Introduction: Project Background

EDG 6 June 2012

Summary of Priorities & Board Recommendations

Westlake Avenue Streetscape

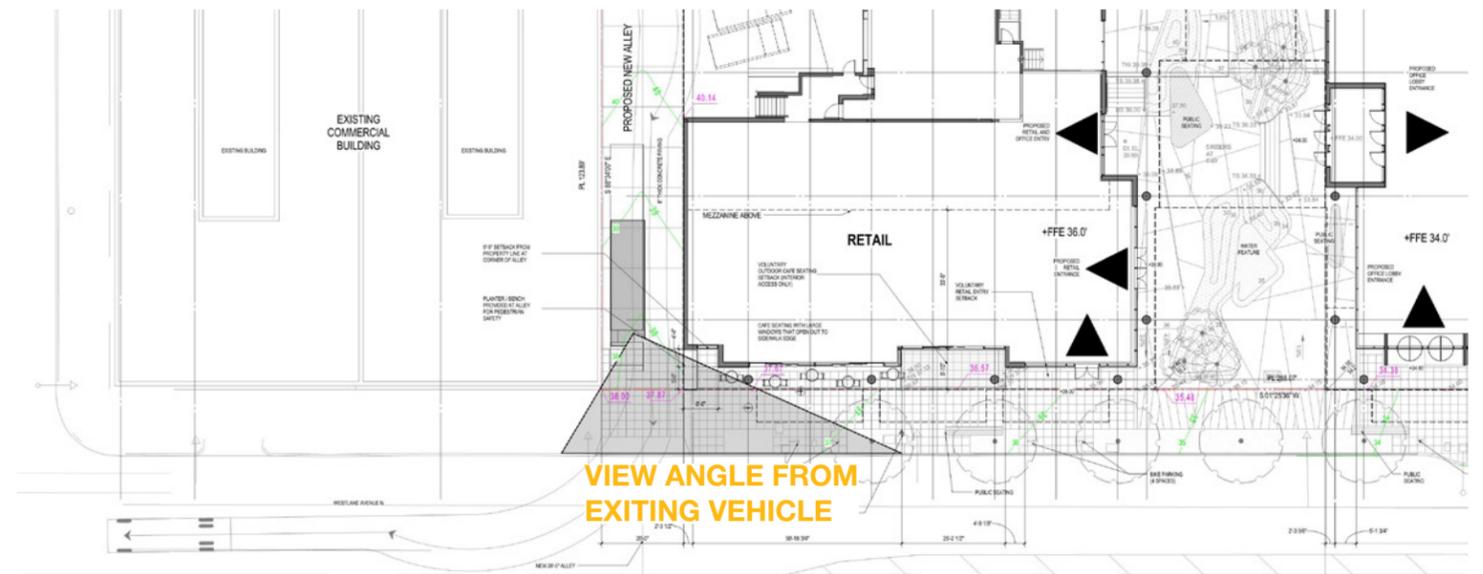
2. Alley exit at Westlake:

- At the Recommendation meeting, the applicant will need to demonstrate adequate vehicular exiting at alley exit to Westlake and create pedestrian safety (mirrors, paving changes, etc.) (A-4, A-8, D-8)
- The Westlake street frontage should be designed to maximize human activity, retail street frontage, and pedestrian safety (A-2, A-4)

Westlake street frontage is activated by Retail and lobby uses. The alley connection has been designed to achieve clear sightlines while signaling the end of the pedestrian zone. A new integrated Streetcar waiting and ticket station will be incorporated.

- The southern corner of the Retail frontage has been set back approximately 10 feet, extending the public realm at the sidewalk and opening view angles for vehicles exiting onto Westlake Ave. N.
- The alley is the minimum dimension allowed by SDOT and is intended to serve as an exit for the loading area and not as an exit for automobiles exiting the parking garage.

3. 9th Ave N frontage:

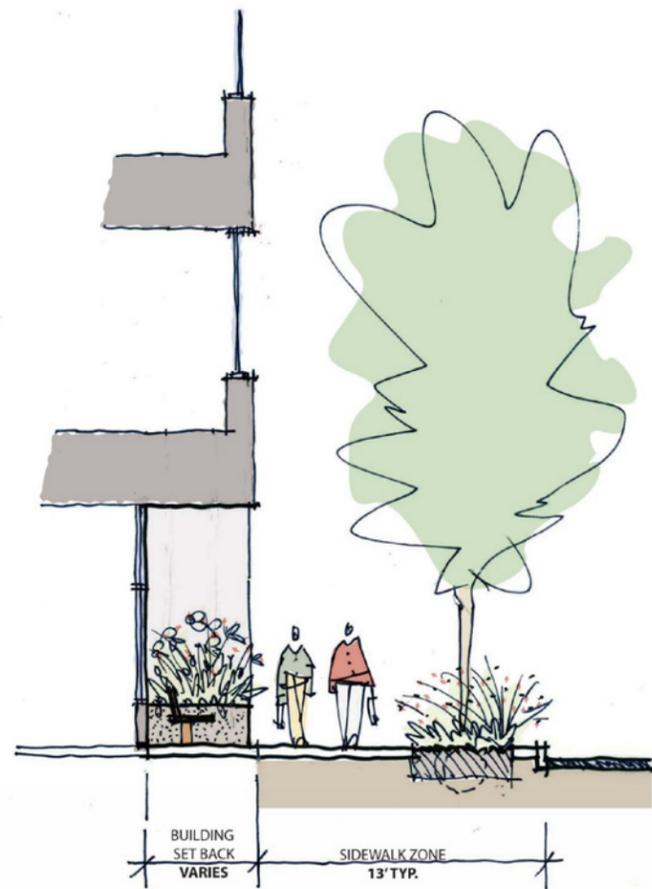
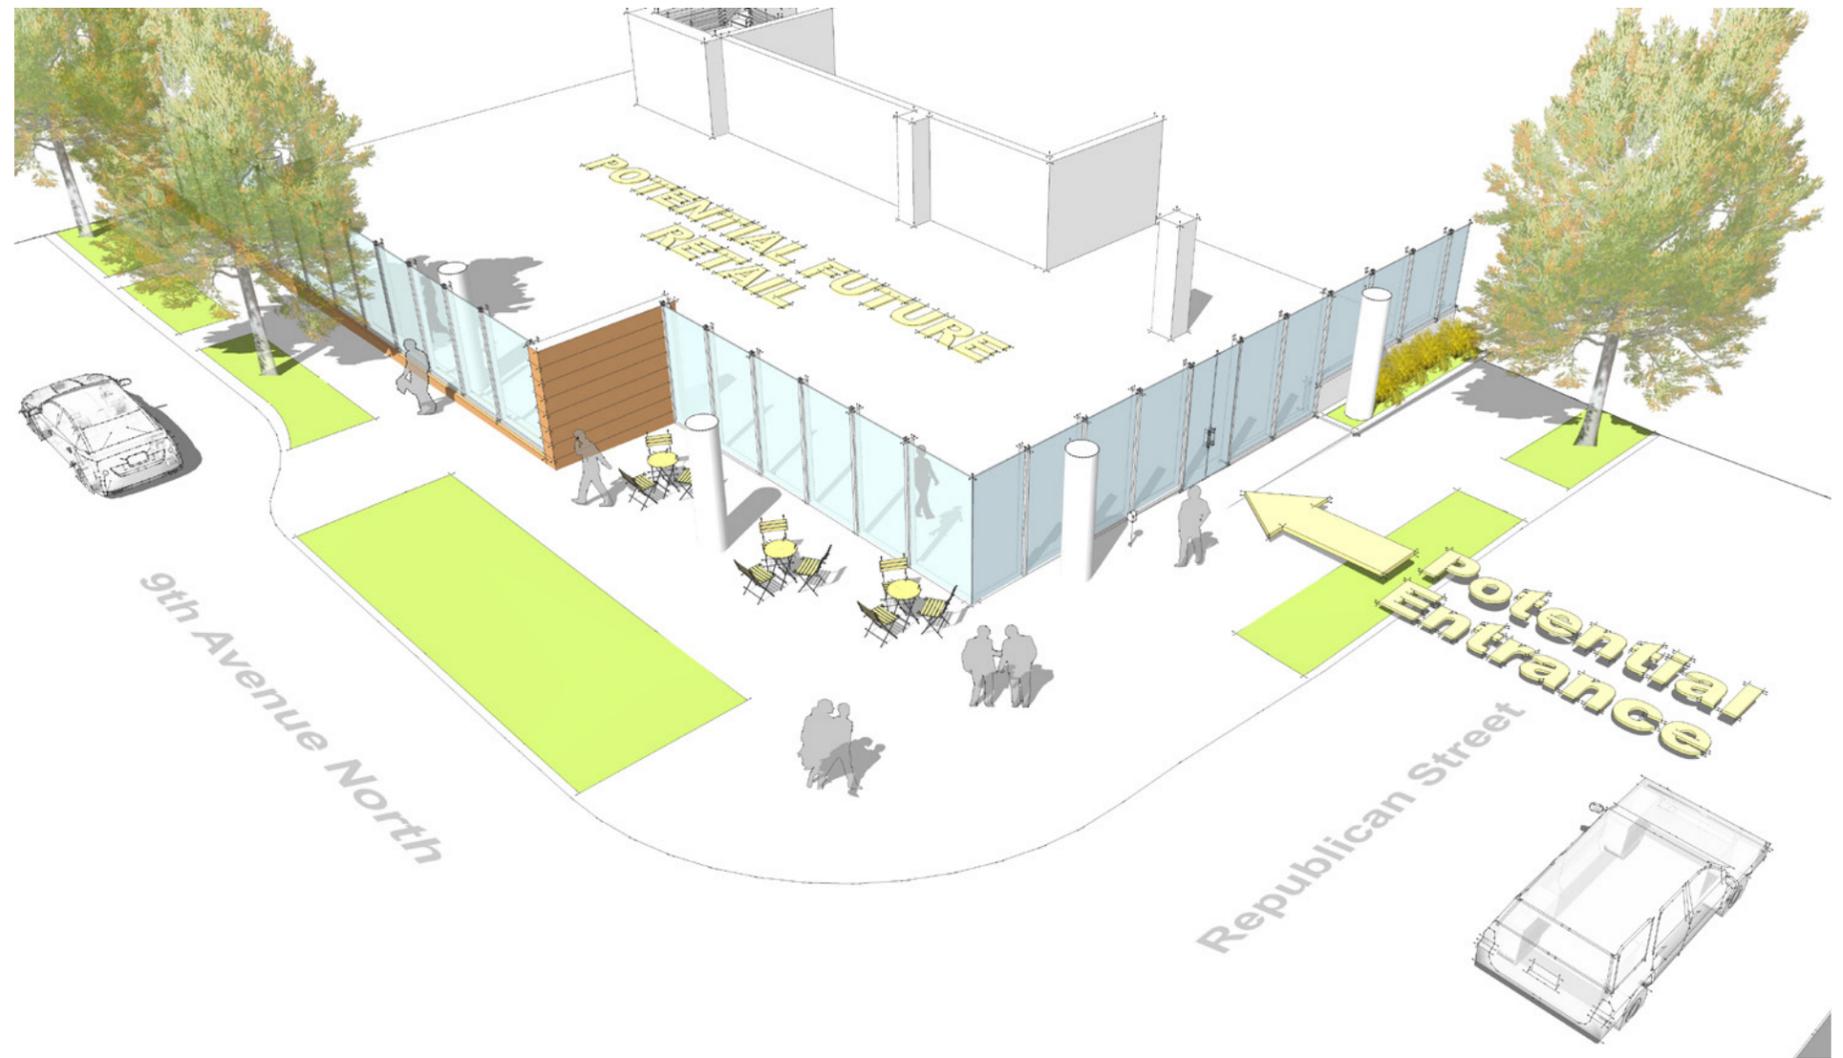
- The west façade should be visually broken up.
- Retail could be difficult on 9th Ave N, if that's considered.
- The building is blocky; the design should include shaping of the mass. Setting back the ground floor may help, as well as articulation, and shaping of the corners. Focus on the pedestrian perspective.

- The design of this façade needs to include significant design moves to break down the appearance of the long façade and to respond to the human scale. (B-1, A-4, C-3)
- This street frontage should be designed to enhance human activity at the street level. The applicant needs to clearly demonstrate how the proposed street level building program on 9th Ave N will meet this guidance. (A-4)

- The Streetscape area near 9th & Republican is designed to allow potential future retail use and sidewalk access.
- The ground floor is modulated with setbacks to add variety and interest, and provide space for hardscape and landscape.

Mid-Block Connection

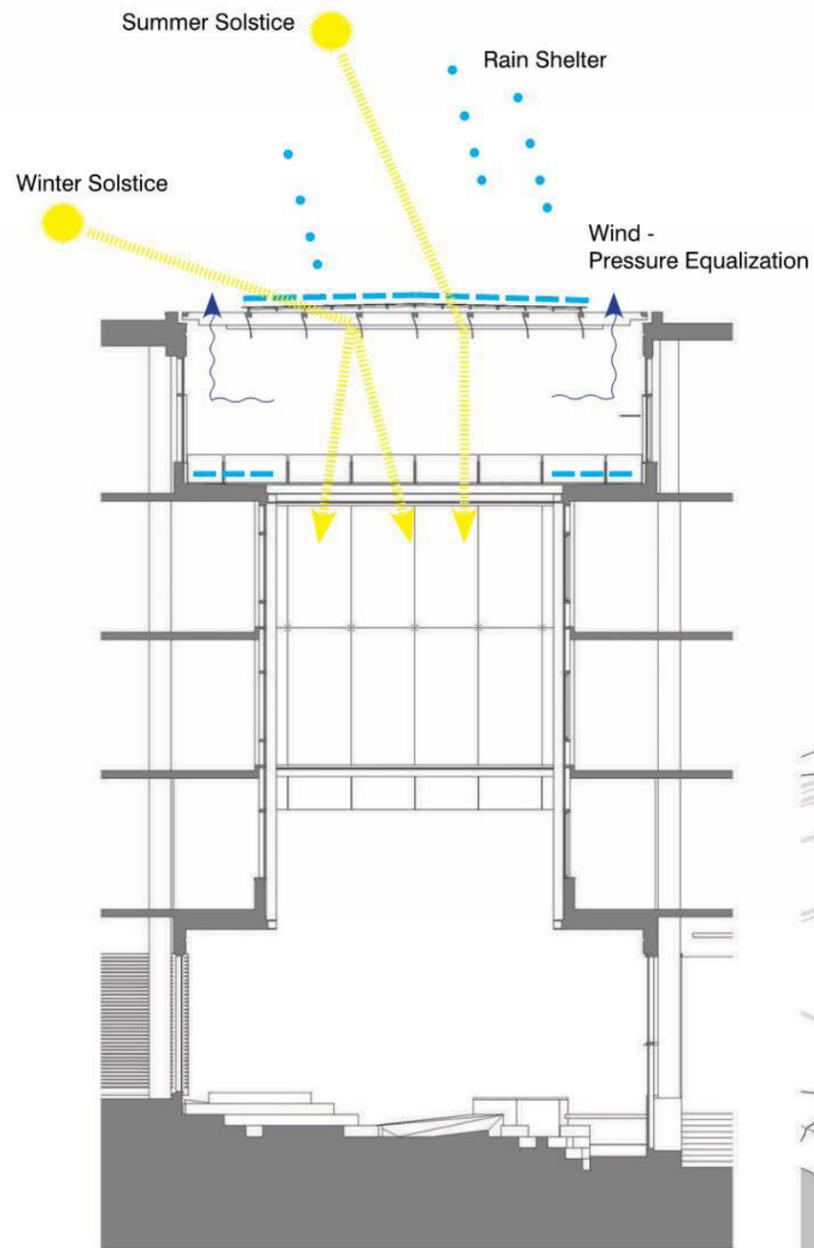
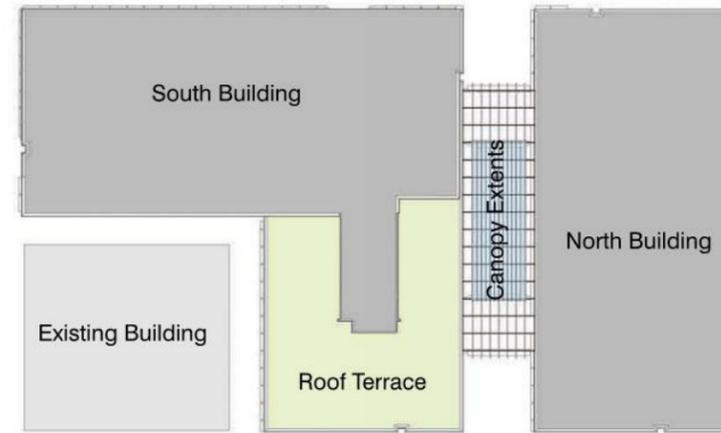
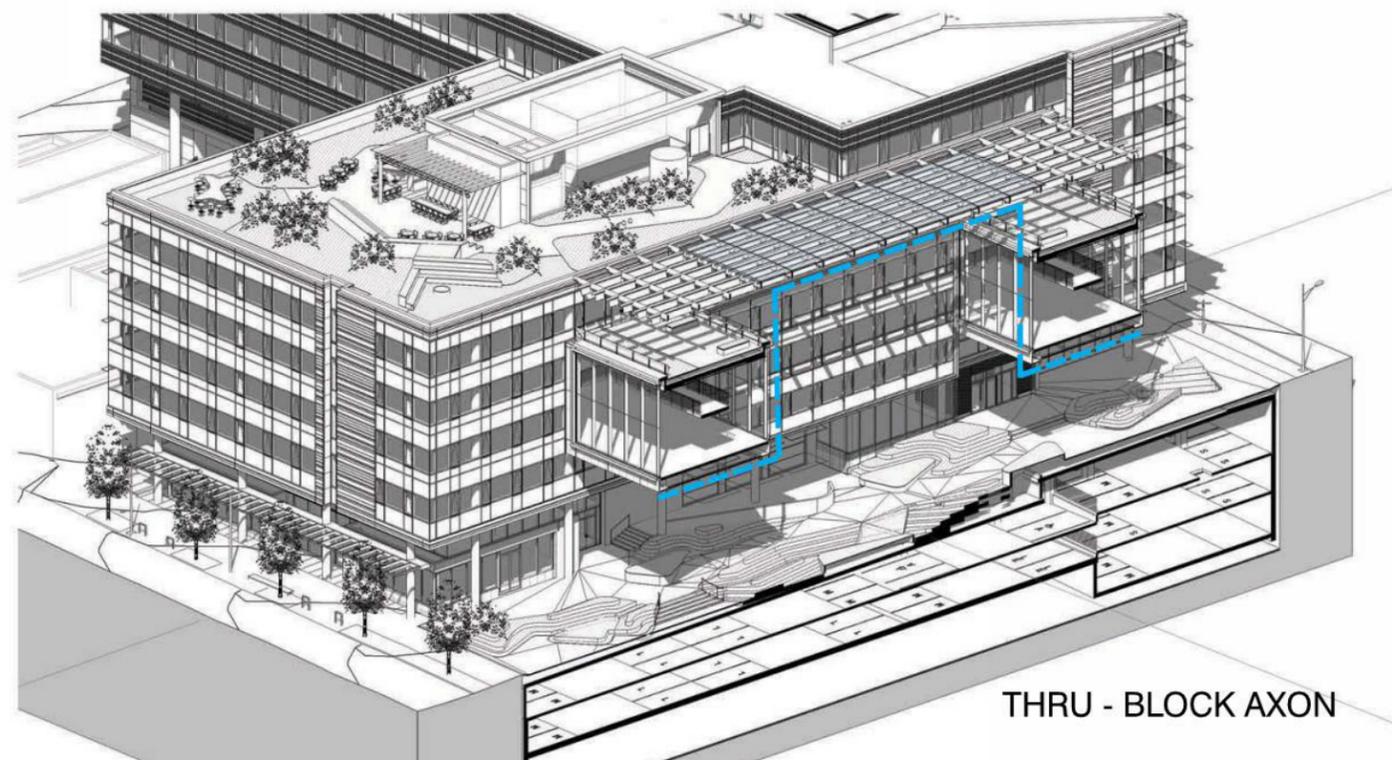
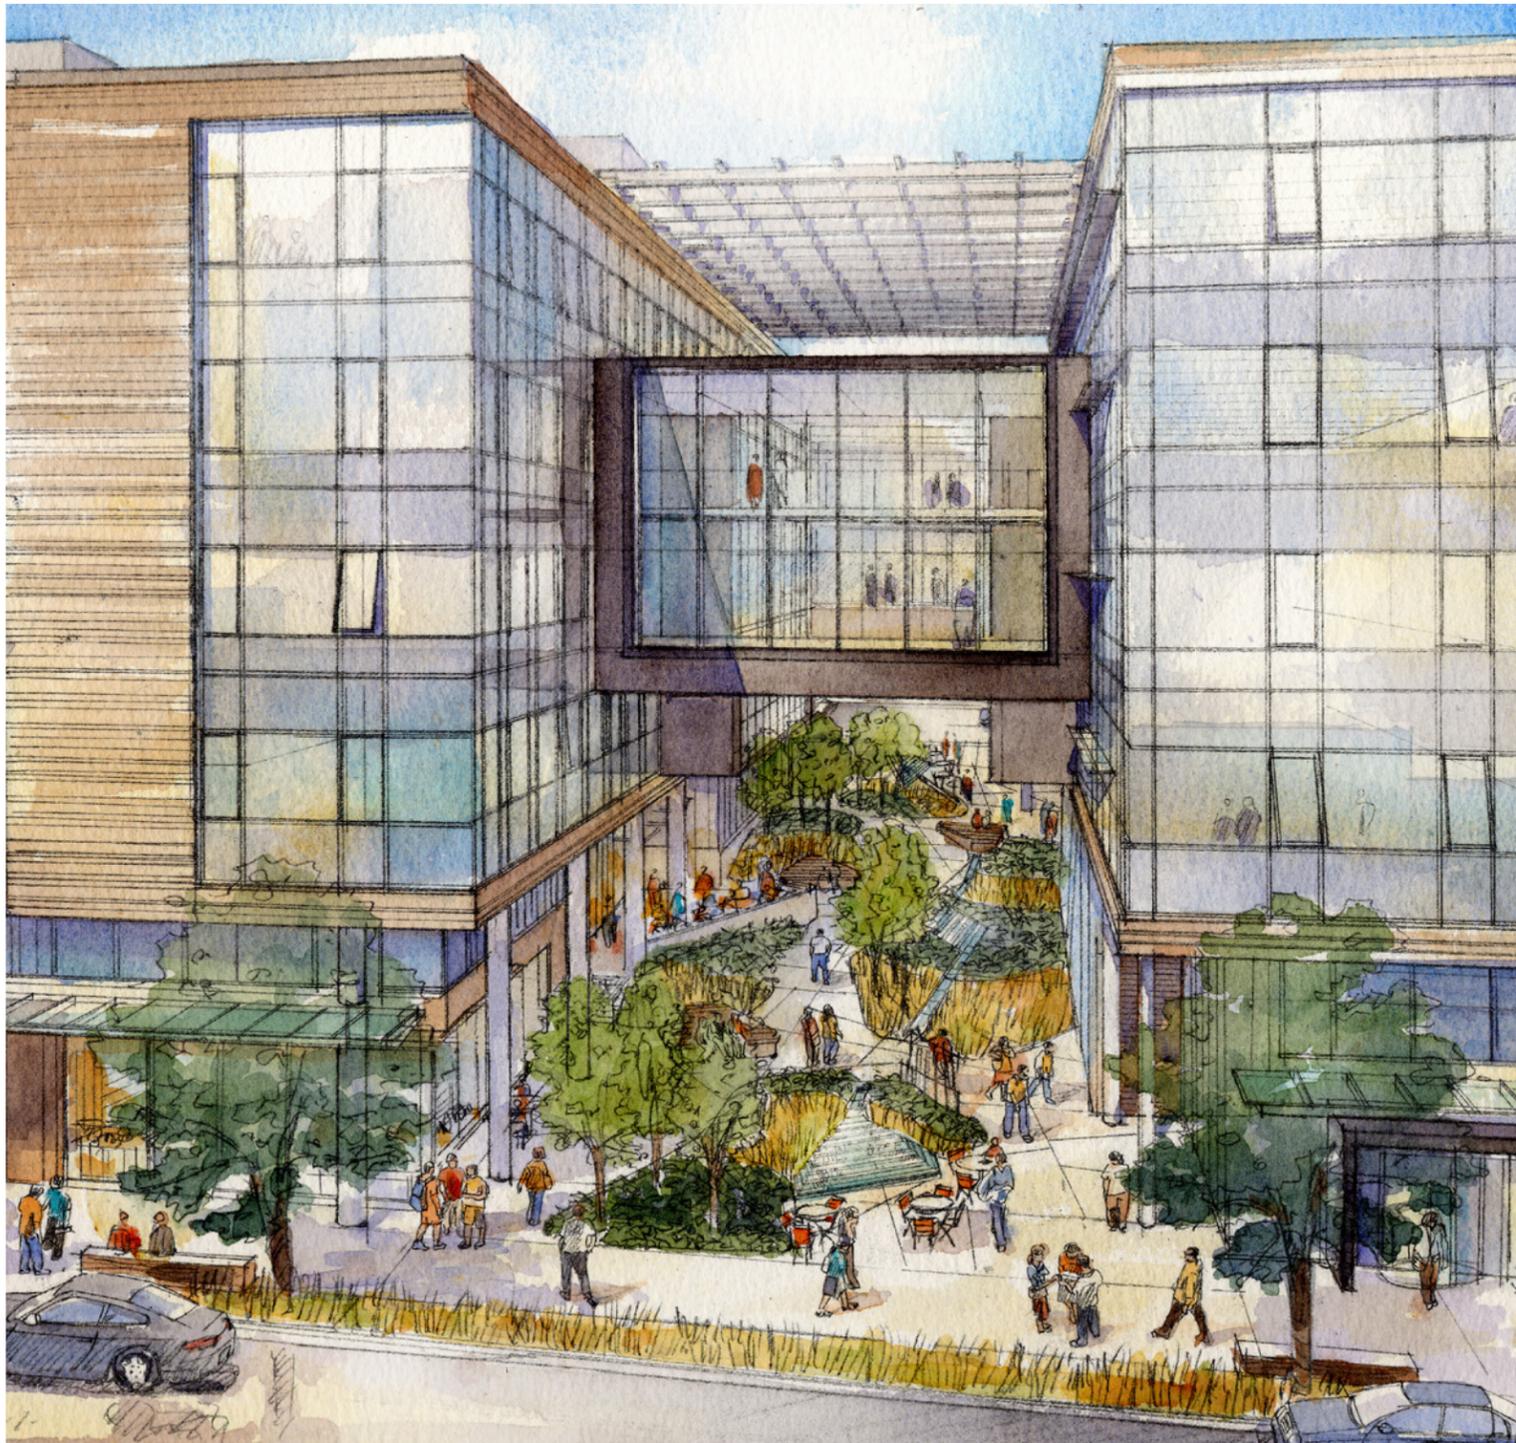
4. The mid-block crossing:

- The location and design should be designed to respond to the UW mid-block crossing to the west. (A-2, C-1, D-1)
- The Board would like to see a lighting plan at Recommendation stage, demonstrating the connection will be safe, well lit, and include maximum natural lighting with supplementary lighting strategies as needed. (D-1, D-7, D-10)

- Orientation of retail to the pedestrian connection is problematic; consider using the retail spaces to activate the street frontages and draw people into the midblock crossing. (A-2, A-4, D-1)

- The corners of the building adjacent to the west end of the crossing should be eroded to enhance the connection with the UW Medicine mid-block crossing to the west. Consider transparent corners in this location. (A-4, D-1)

- The crossing should be designed to clearly appear public and not a private courtyard. (A-4, D-1)
- Design the connection to minimize wind tunnel effects and maximize pedestrian comfort. (D-1)
